**ZONING AMENDMENT,
PLANNED UNIT DEVELOPMENT &
SUBDIVISION STAFF REPORT****Date: December 5, 2013**

<u>NAME</u>	John Kirby
<u>SUBDIVISION NAME</u>	Kirby Subdivision
<u>LOCATION</u>	7049 Dickens Ferry Road and 7060 & 7068 Airport Boulevard (North side of Airport Boulevard extending to the South side of Dickens Ferry Road, 550'± East of Cody Road)
<u>CITY COUNCIL DISTRICT</u>	District 7
<u>PRESENT ZONING</u>	R-1, Single-Family Residential District
<u>PROPOSED ZONING</u>	B-3, Community Business District
<u>AREA OF PROPERTY</u>	1 Lot / 1.4± Acres
<u>CONTEMPLATED USE</u>	Rezoning from R-1, Single-Family Residential District, to B-3, Community Business District, to eliminate split zoning, Planned Unit Development Approval to allow multiple buildings on a single building site and share access between two building sites, and a Subdivision to create one legal lot of record from a single metes-and-bounds parcel. It should be noted, however, that any use permitted in the proposed district would be allowed at this location if the zoning is changed. Furthermore, the Planning Commission may consider zoning classifications other than that sought by the applicant for this property.

SITE PLAN

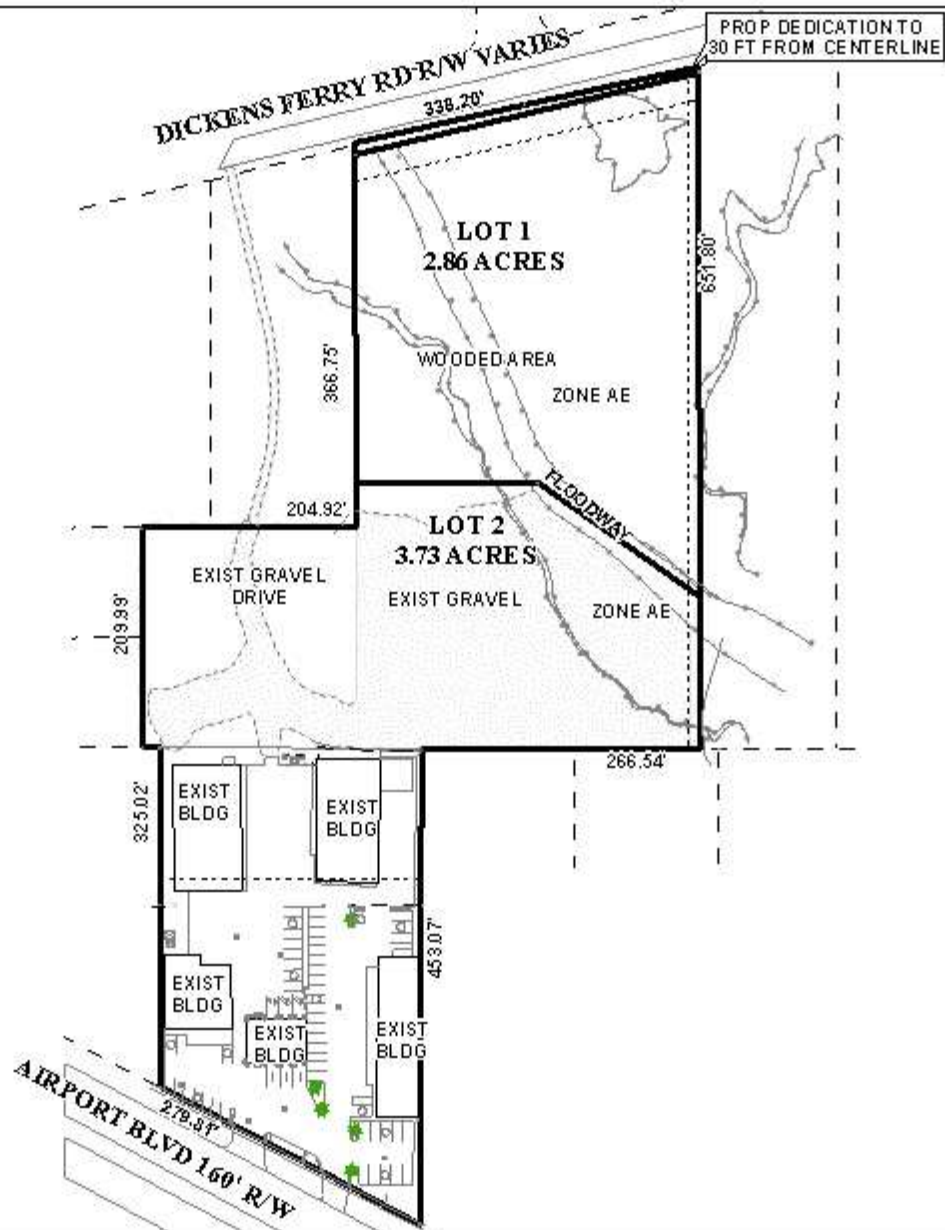
Lot 1 of Spectrum Subdivision was removed from the PUD, however the site plan still illustrates cross access to this lot. Commercial access to Dickens Ferry is denied.

Need revised site plan showing Live Oak Trees 24" and larger. Also show on the site plan the removal of existing gravel from the Critical Root Zone of the existing Live Oak Trees 24" and larger.

The site plan provided does not illustrate any parking on the site, nor does it provide any information regarding landscaped area, tree plantings, what type of business occupies each of the existing structures, or if the site will use a dumpster or curb-side service. The site plan should be revised to include this information, as well as any other information indicating compliance with the Zoning Ordinance.

The site plan has been revised to include three (3) adjacent lots that have shared access as requested. The applicant has also included the type of business on each lot, the building sizes, and illustrated all existing parking. However, several of the businesses are automobile repair shops, and no distinction is made between office space and the bays where cars will be worked on, nor is the number of employees provided. Because of the omission of this information, it is difficult for staff to determine if the 51 existing parking spaces are sufficient to comply with Section 64-6.6. of the Zoning Ordinance, however, because no building expansion is proposed at this time, no additional parking spaces should be required if the existing number is adequate. However, it should be noted that any future additions to any of the structures will require full compliance with parking.

Staff requested that information be submitted regarding landscaping and tree calculations. It should be noted that no information was provided about the amount of landscaped area or tree plantings; however several trees are illustrated along Airport Boulevard with no mention of their size or species.

Urban Forestry requested that the revised site plan include information regarding Live Oak trees larger than 24"; however no such information has been provided. If approved, all information requested by Urban Forestry should be provided.

The revised site plan illustrates several dumpsters which serve the development; however, no mention is made as to what screening, if any, exist. The site plan should be revised to illustrate dumpsters in compliance with Section 65-4.D.9. of the Zoning Ordinance.

The revised site plan also does not include the illustration of, or a note regarding the provision of a residential buffer in compliance with Section 64-4-D.1. of the Zoning Ordinance as requested by staff.

- 1) illustrate dedication if necessary to provide 30' from the centerline of Dickens Ferry Road;*
- 2) removal of connection with dirt drive access to Dickens Ferry Road, or provision of a 6' high privacy fence to block access;*

- 3) placement of a note stating commercial access to Dickens Ferry Road is denied;*
- 4) placement of a note stating that Lot 1 is be allowed one curb cut to Dickens Ferry Road, with the size, location and design to be approved by Traffic Engineering and conform to AASHTO standards;*

- 5) retention of the note stating that no structures are to built in any easement;*
- 6) provide landscaping and tree planting calculations for entire PUD;*

- 7) illustration of all dumpsters compliant with Section 64-4.D.9 of the Zoning Ordinance;*
- 8) illustration of the required residential buffer per Section 64-4.D.1. of the Zoning Ordinance;*
